# Access Compliance Report

## Public Rights-of-Way

### (Curb Ramps)

Intersection ID: 28061	Main Street: CORRYSTONE_DR	Cross Street: WILLOW_ROCK_DR	Location: E
ADA ID: B111CEDE2961	Ramp Type: PerpDiag	Initial Pass/Fail: Fail	Overall Compliance: No
Severity Score: 31.25			
Codes/Mitigation Info/Possible Solution		Field Measurements/Component Compliance

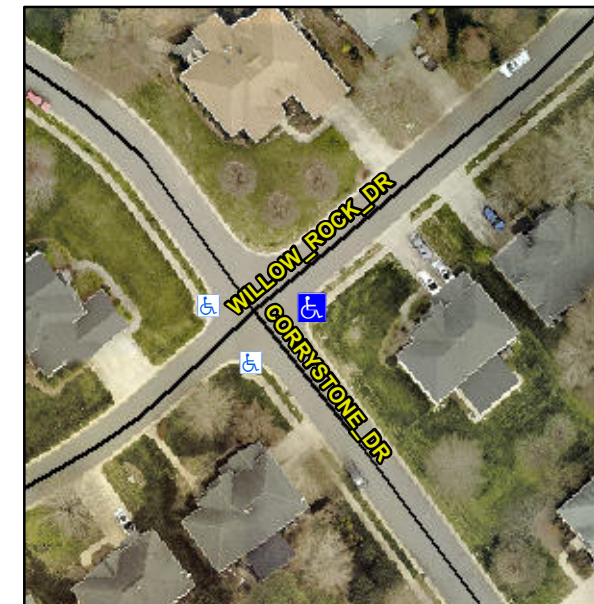
**Not Found, R304.5.1, R304.2.2, R304.5.3**

Compliance	Description	Data	Compliance	Description	Data
N/A	Ramp Length (in)	96.0	No	Ramp Slope (%)	8.8
No	Ramp Width (in)	33.5	No	Ramp XSlope (%)	3.8
N/A	Flare Type LT	N/A	N/A	Flare Type RT	N/A
N/A	Flare Slope LT (%)	N/A	N/A	Flare Slope RT (%)	N/A
N/A	Flare Traversable LT?	N/A	N/A	Flare Traversable RT?	N/A
N/A	Landing Length (in)	N/A	N/A	DWS Provided?	N/A
N/A	Landing Width (in)	N/A	N/A	DWS Contrast?	N/A
N/A	Landing Slope (%)	N/A	N/A	DWS Length (in)	N/A
N/A	Landing X Slope (%)	N/A	N/A	DWS Full Width?	N/A
N/A	Landing Curb? (Y/N)	N/A	N/A	DWS Offset (in)	N/A
N/A	Shared Landing?	N/A			
N/A	Gutter Ponding?	N/A	N/A	Gutter Slope (%)	N/A
N/A	Gutter Lip Ht (in)	N/A	N/A	Gutter X Slope (%)	N/A
N/A	Painted X Walk1?	No	N/A	Painted X Walk2?	No
	X Walk 1 Direction	To NW		X Walk 2 Direction	To SW
N/A	X Walk 1 Width (in)	N/A	N/A	X Walk 2 Width (in)	N/A
	X Walk 1 Slope (%)	4.6		X Walk 2 Slope (%)	6.8
	X Walk 1 X Slope (%)	3.1		X Walk 2 X Slope (%)	1.4

**Remove & Replace Curb Ramp With Two New Directional Ramps or Equivalent.**
